## SERVICE BULLETIN

N° **189-240**

**REV. :** A - October 25, 2021

**ATA 46 - INSTALLATION OF AVIONIC FLIGHT SOFTWARE RELEASE PHASE 6.0**

**Figure 1**

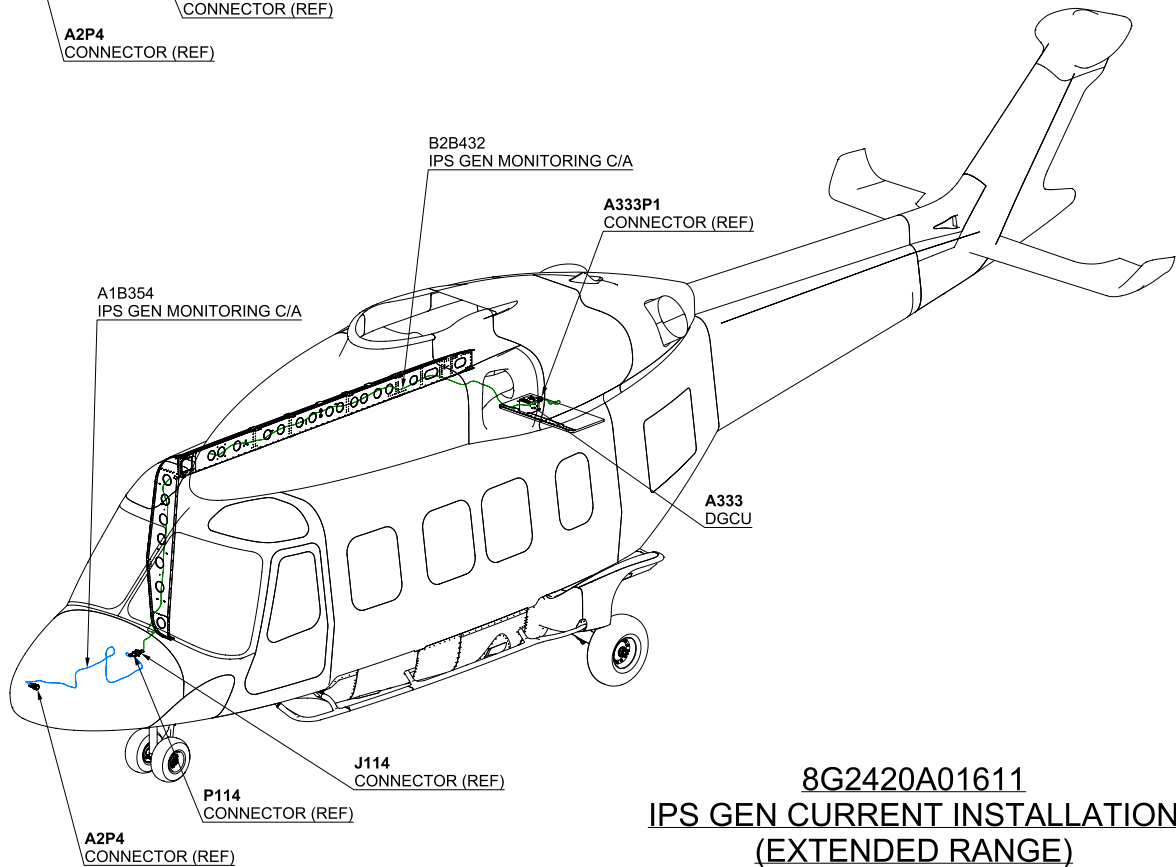
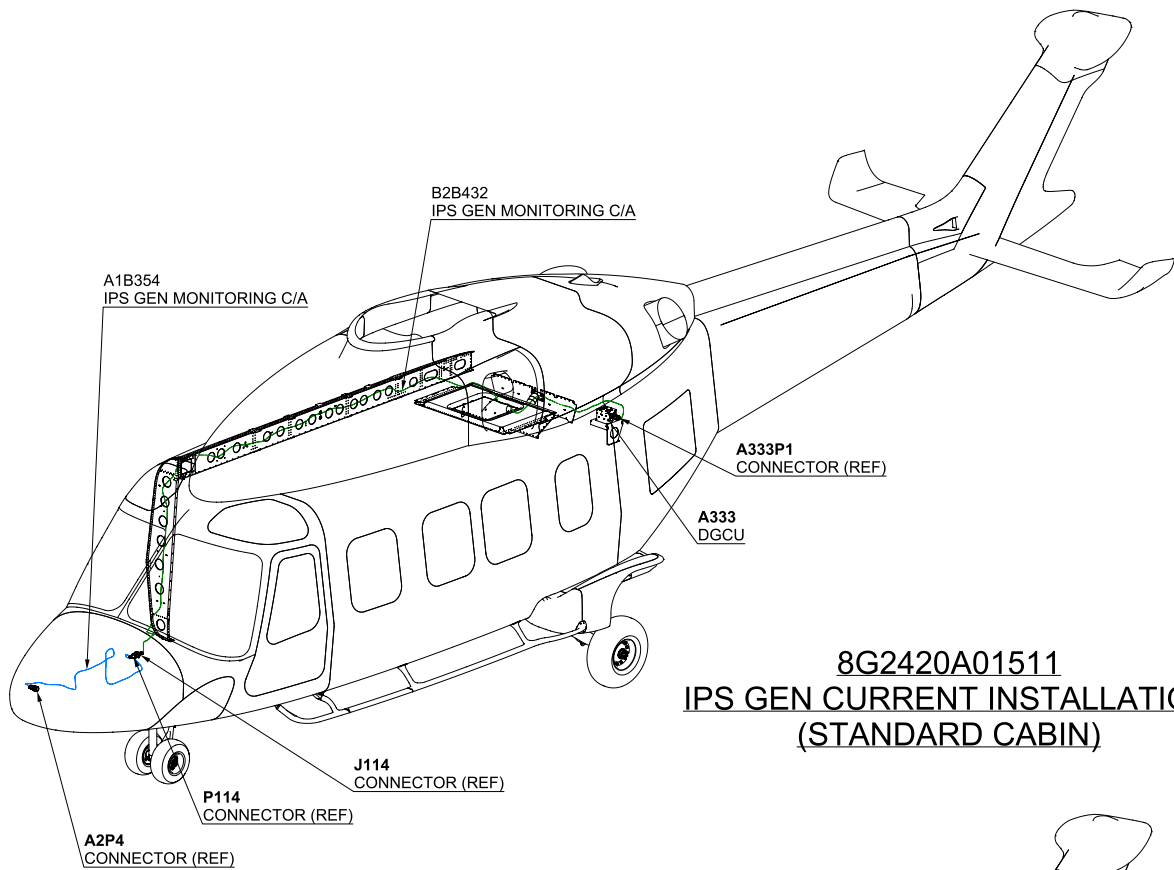
2. Perform the IPS GEN CURRENT INSTL (std-cabin) P/N 8G2420A01511 or IPS GEN CURRENT INSTL U/B (Extended Range Cabin) P/N 8G2420A01611 as described in the following procedure:
  - 2.1 With reference to Figures 1 to 3 route the following cables following the existing routes unless otherwise indicated on the figures:
    - 8G9A21B35401 IPS GEN MONITORING C/A (A1B354)
    - 8G9B21B43201 IPS GEN MONITORING C/A (B1B432) (only std-cabin helicopters).
    - 8G9B21B43202 IPS GEN MONITORING C/A (B1B432) (only Extended Range helicopters).
  - 2.2 With reference to Figure 4 wiring diagram, perform electrical connection of the cable assy A1B354 to connector A2P4 and to connector P114.
  - 2.3 With reference to Figure 4 wiring diagram, perform electrical connection of the cable assy B2B432 to connector J114 and to connector A333P1.

**Figure 6**

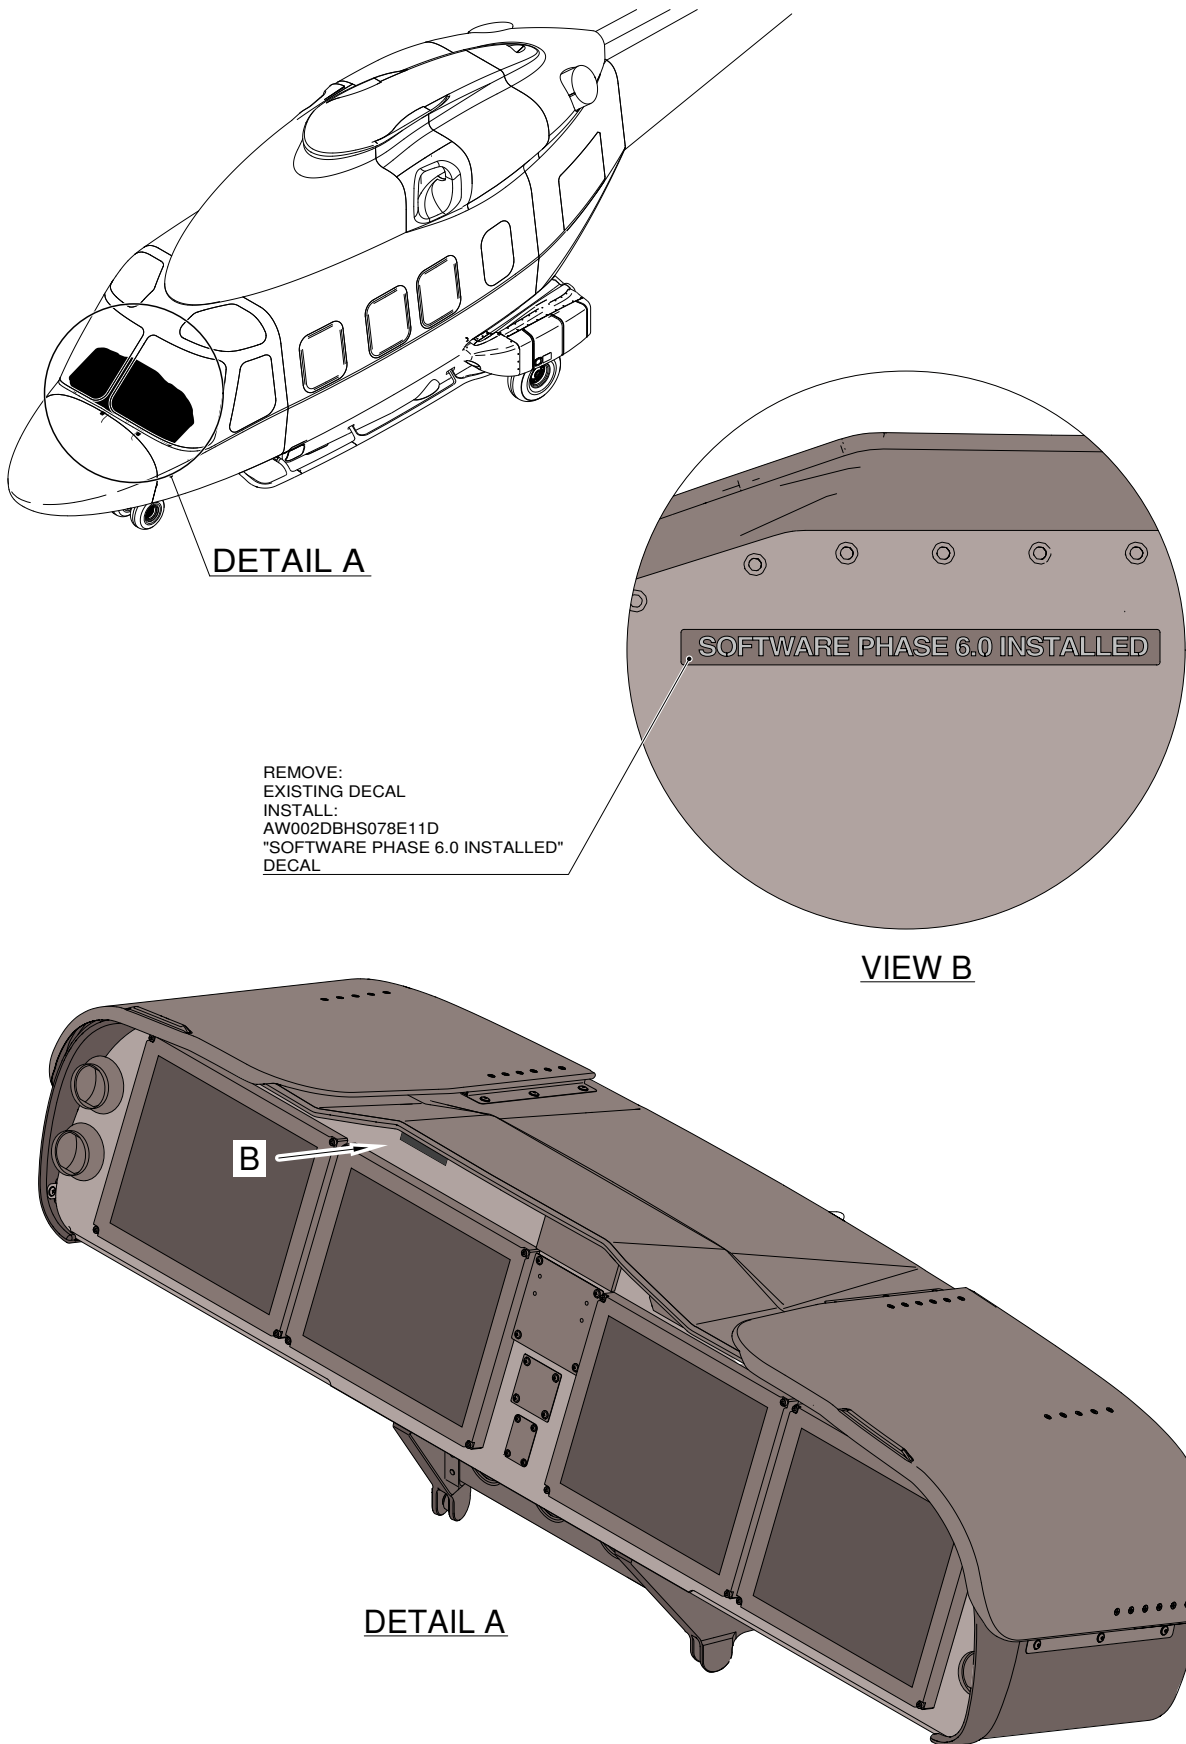
16. In accordance with AMP DM 89-B-34-44-05-00A-752A-A, install TSS configuration file P/N 8G3450AO0001 or P/N 8G3450AO0002.
17. With reference to Figure 6, replace existing decal with decal P/N AW002DBHS078E11D "SOFTWARE PHASE 6.0 INSTALLED".

**Figure 7**

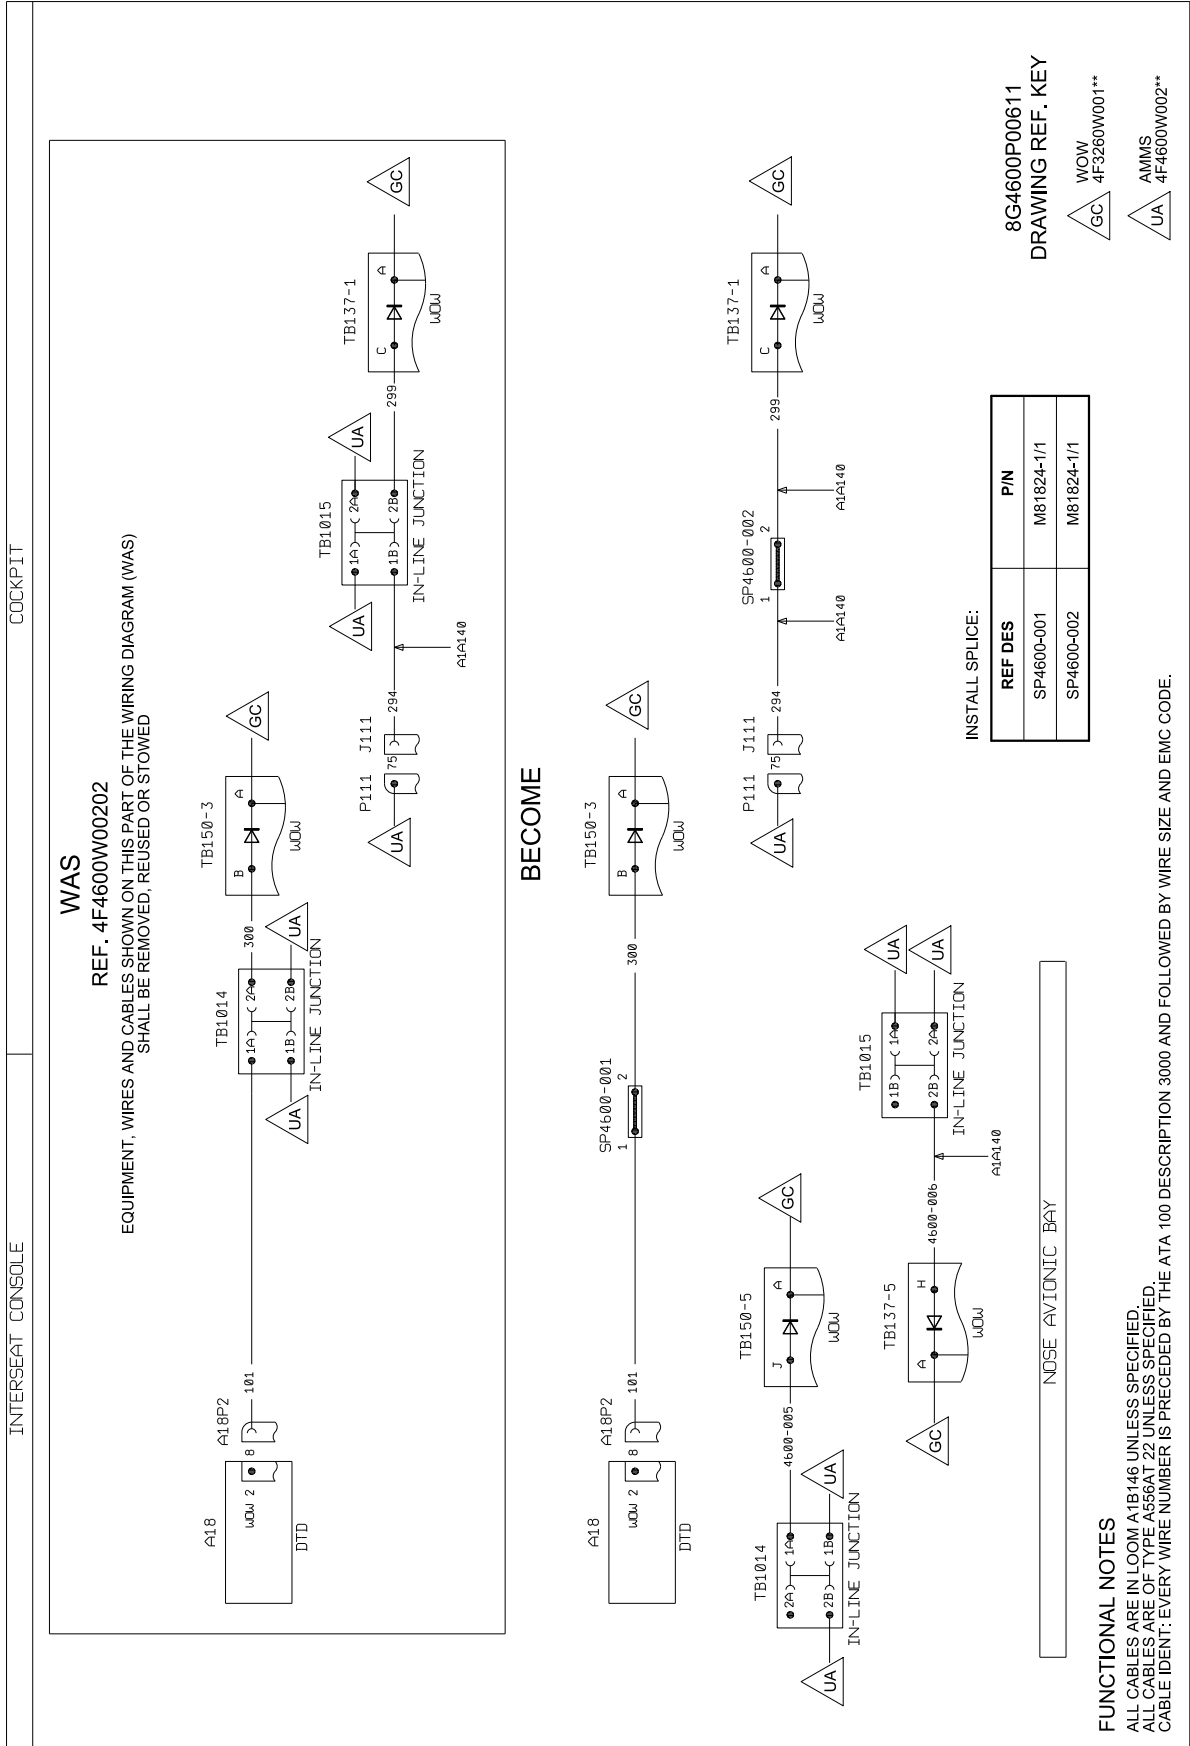
- 6.1 In accordance with AMP DM 89-A-46-21-05-00A-520A-A, remove existing DTD P/N 4F4620V00551 from the helicopter.
  - 6.2 With reference to Figure 7 wiring diagram, perform the DTD upgrade retromod P/N 8G4600P00611 as described in the following procedure:

- 6.2.1 From the TB1014, disconnect the pin 1A and the pin 2A; connect together the wire 4600-101-22G and 4600-300-22G by means of n°1 splice P/N M81824/1-1. Mark the splice as SP4600-001.

- 6.2.2 Cut a piece of wire P/N A556A-T22 at adequate length between TB1014 and TB150-5, following existing cable routing; crimp on each wire end a contact P/N A523A-A02 and connect the pin 1A of TB1014 with pin J of TB150-5. Install n°2 marker sleeve A579A02-002, one near each TB, and mark the wire as 4600-005.

- 6.2.3 From the TB1015, disconnect the pin 1B and the pin 2B; connect together the wire 4600-294-22G and 4600-299-22G by means of n°1 splice P/N M81824/1-1. Mark the splice as SP4600-002.

- 6.2.4 Cut a piece of wire P/N A556A-T22 at adequate length between TB1015 and TB137-5, following existing cable routing; crimp on each wire end a contact P/N A523A-A02 and connect the pin 2B of TB1015 with pin H of TB137-5. Install n°2 marker sleeve A579A02-002, one near each TB, and mark the wire as 4600-006.

**Figure 8**

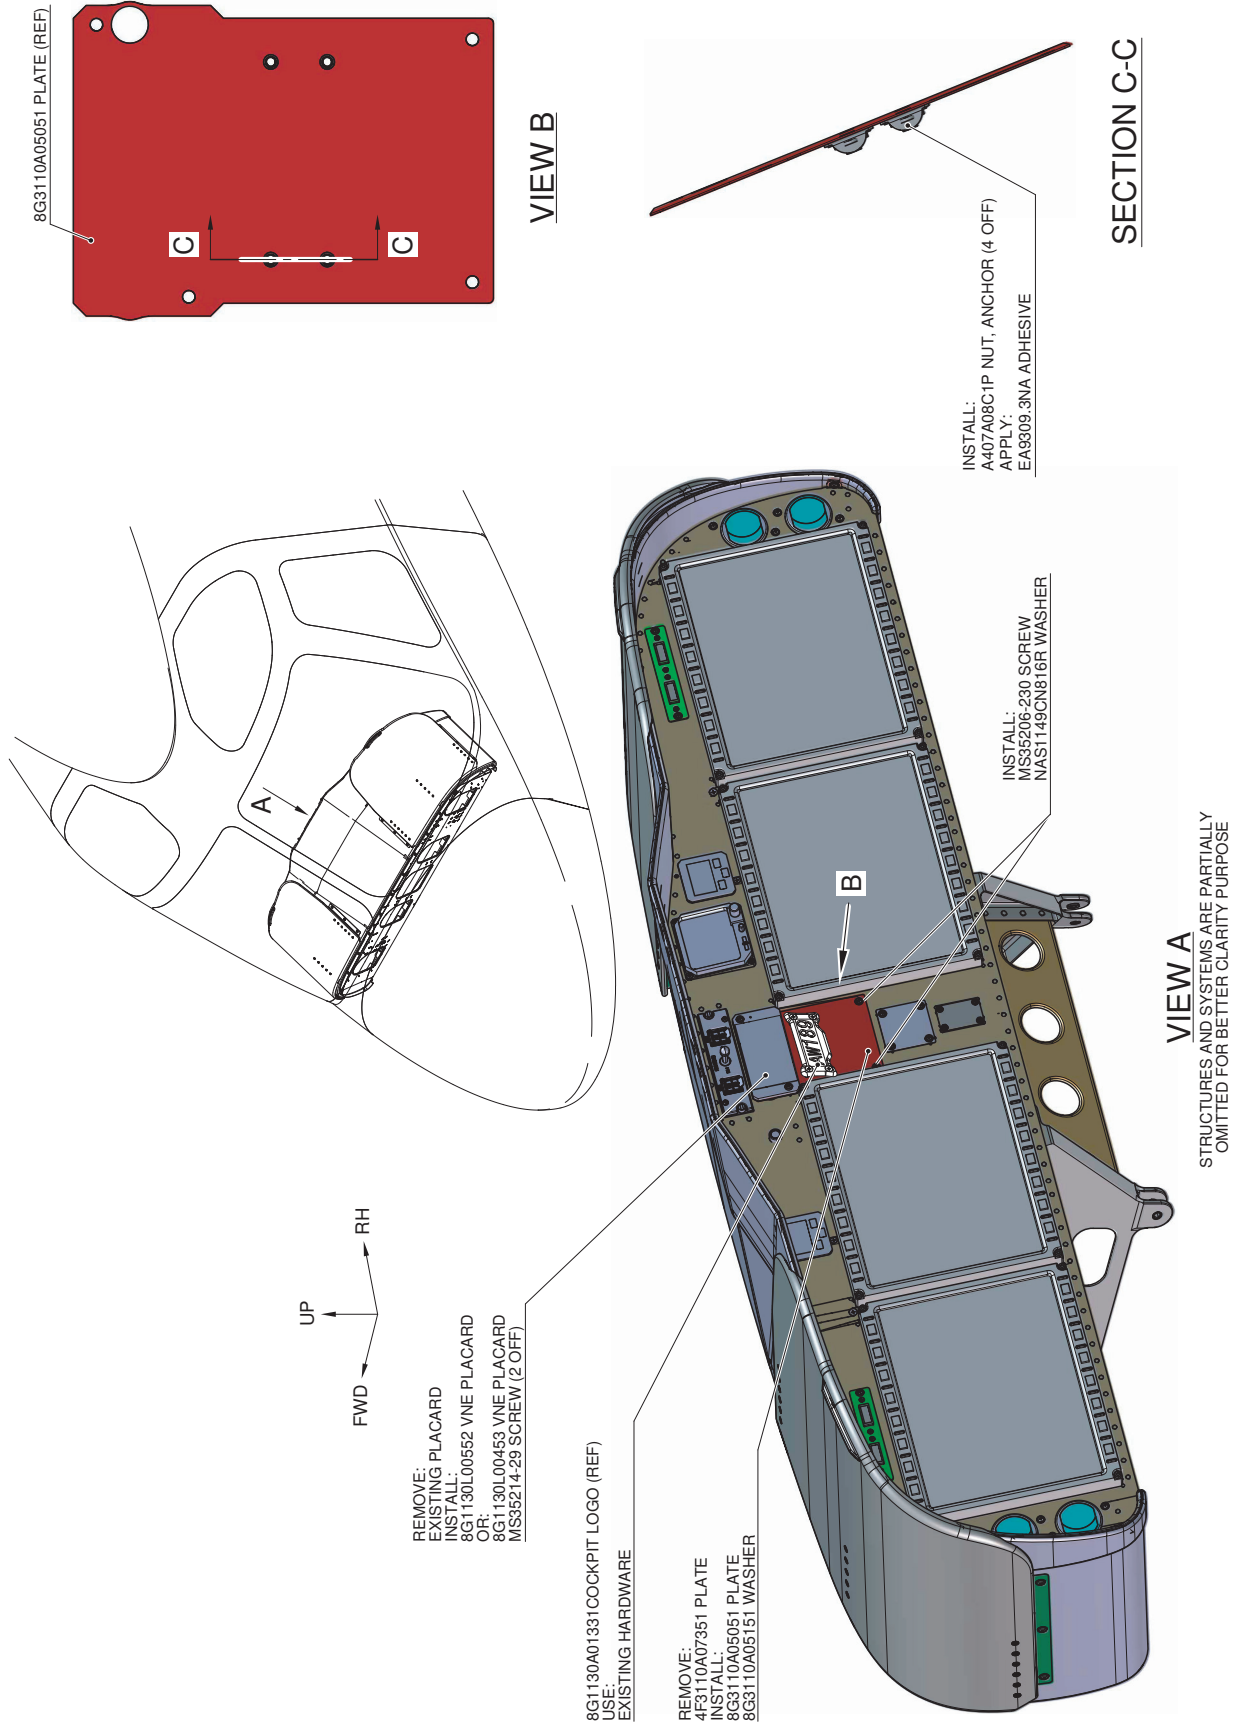
20. With reference to Figure 8, gain access to the cockpit area and perform the VNE placard retromod P/N 8G3110P00811 as described in the following procedure:
  - 20.1 With reference to Figure 8 View A, remove the existing placard. Discard the existing hardware.
  - 20.2 With reference to Figure 8 View A, remove the cockpit logo P/N 8G1130A01331. Retain existing hardware for later reuse.
  - 20.3 With reference to Figure 8 View A, remove plate P/N 4F3110A07351. Discard the existing hardware.
  - 20.4 With reference to Figure 8 View B and section C-C, install n°4 nut plates P/N A407A08C1P by means of EA9309.3NA adhesive on the plate P/N 8G3110A05051.
  - 20.5 With reference to Figure 8 View A, install washer P/N 8G3110A05151 and plate P/N 8G3110A05051 by means of n°2 screws P/N MS35206-230 and n°2 washers P/N NAS1149CN816R.

- 20.6 With reference to Figure 8 View A, install VNE placard P/N 8G1130L00552 by means of n°2 screws P/N MS35214-29.
- 20.7 With reference to Figure 8 View A, re-install the cockpit logo P/N 8G1130A01331. Use existing hardware.

21. With reference to Figure 8, gain access to the cockpit area and perform the following procedure:
  - 21.1 With reference to Figure 8 View A, remove the existing placard. Retain existing hardware for later reuse.
  - 21.2 With reference to Figure 8 View A, install the VNE placard P/N 8G1130L00453 by means of previously removed hardware.

**Figure 9**

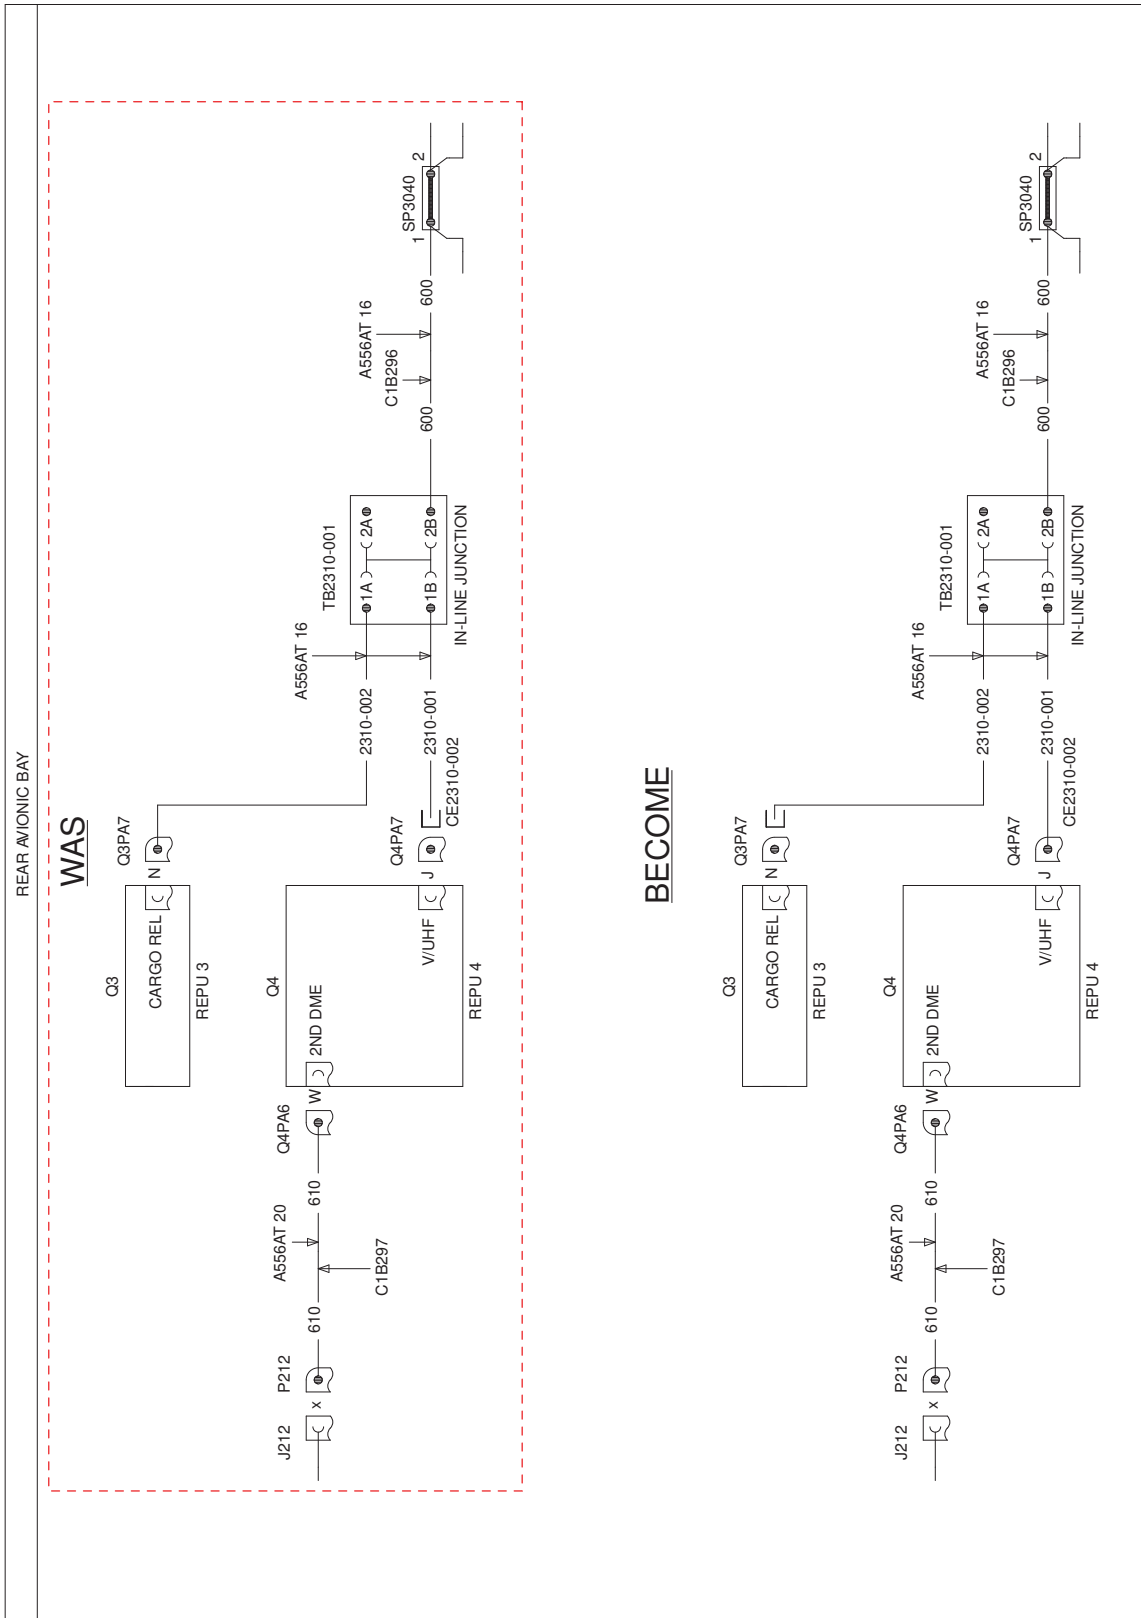
22. With reference to Figure 9, perform the electrical change as described in the following procedure:
  - 22.1 In accordance with AMP DM 89-A-06-41-00-00A-010A-A, remove access panels 165D, 168A and 169A to gain access to the REPU 3 and REPU 4 areas.
  - 22.2 With reference to Figure 9, disconnect wire 2310-002 from REPU 3 connector Q3PA7 pin N and stow it properly.
  - 22.3 With reference to Figure 9, connect wire 2310-001 to REPU 4 connector Q4PA7 pin J.
23. Remove all the tools and other items from the work area.
24. Return the helicopter to flight configuration and record for compliance with this Service Bulletin on the helicopter logbook.
25. Send the attached compliance form to the following mail box:
